BIRMINGHAM CITY COMMISSION
PROPOSED LOT SPLIT

SUBJECT: **Set Public Hearing for a Lot Split of 1530 Pilgrim, Parcel #1926226002,** T2N, R10E, SEC 26 PHILP QUARTON ROAD ESTATES LOT 3 & SLY 40 FT OF LOT 4

SHEET 2 of 2

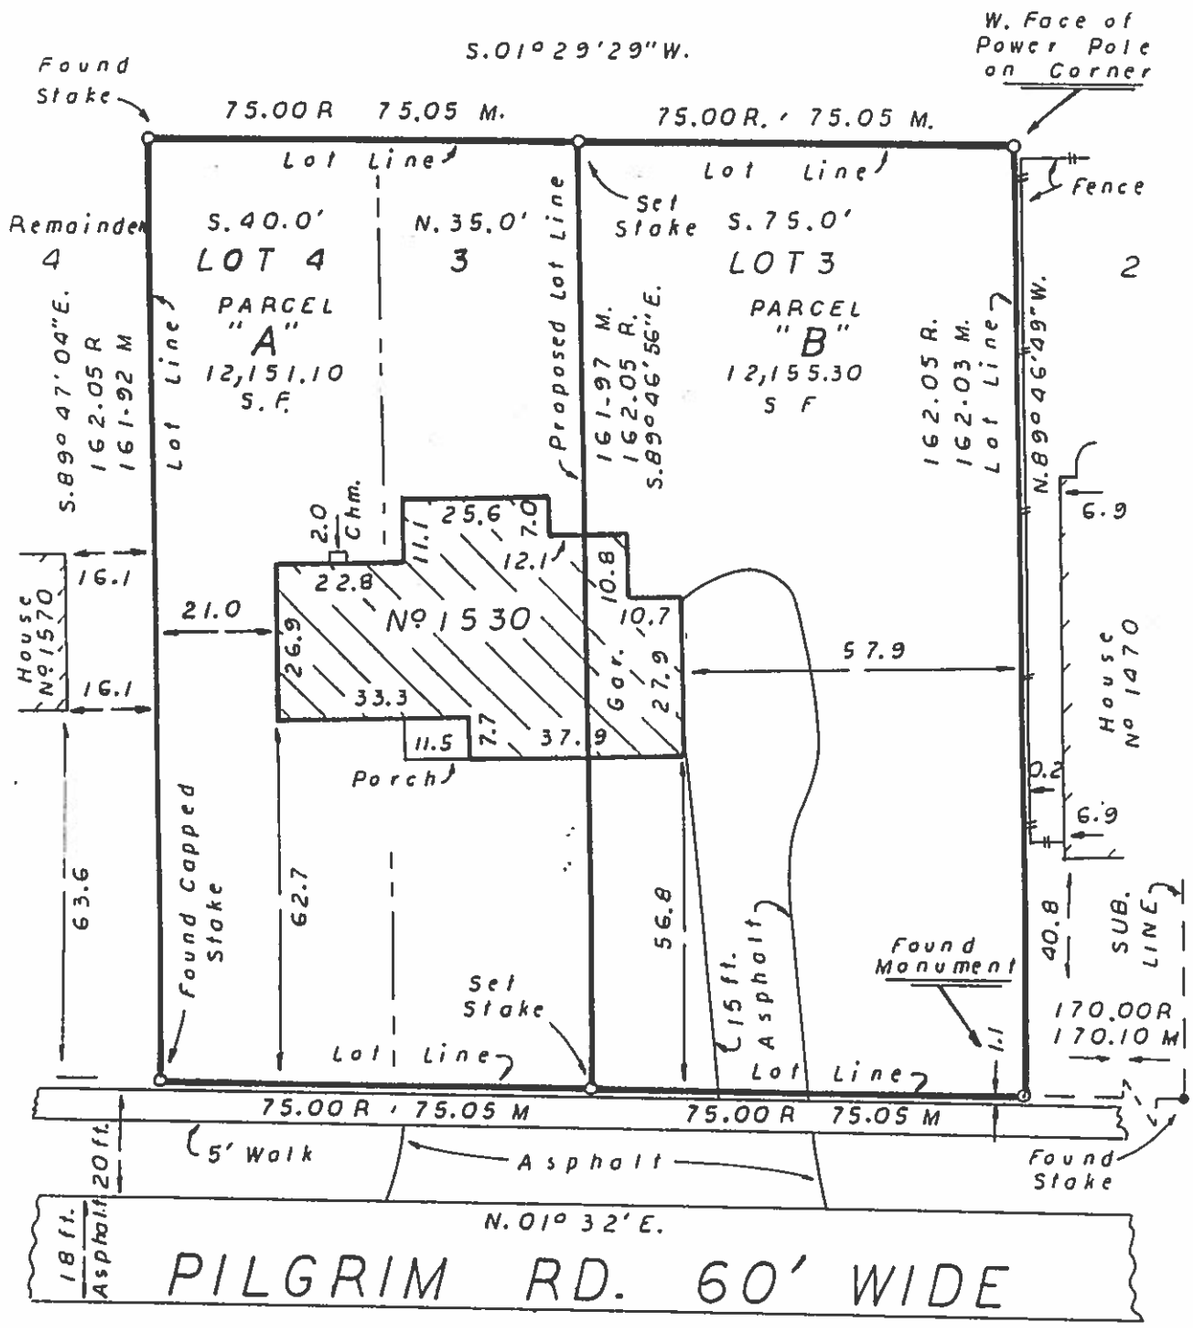
Attached are copies of the survey provided by the applicant depicting existing and proposed conditions. The proposed rearrangement has been reviewed by the Community Development Department. The subject parcels are zoned R1A (Single-Family Residential). The minimum lot size for R1A is 20,000 sq. ft.

The resulting lot sizes proposed for the two (2) parcels will be smaller than 20,000 sq. ft. The combined size of the existing parcels is approximately 20,516.1. The size of the new parcels would be 12,153.75 sq. ft. for each parcel. **Accordingly, the resulting parcels are not in compliance with this requirement.** The minimum lot size for R1 is 9,000 sq. ft.

The resulting lot width of the proposed residential lots would be 75 for each parcel. The average lot width for the R1A parcels within 300' is 108.37 feet. **Accordingly, the resulting parcels are not in compliance with this requirement.**
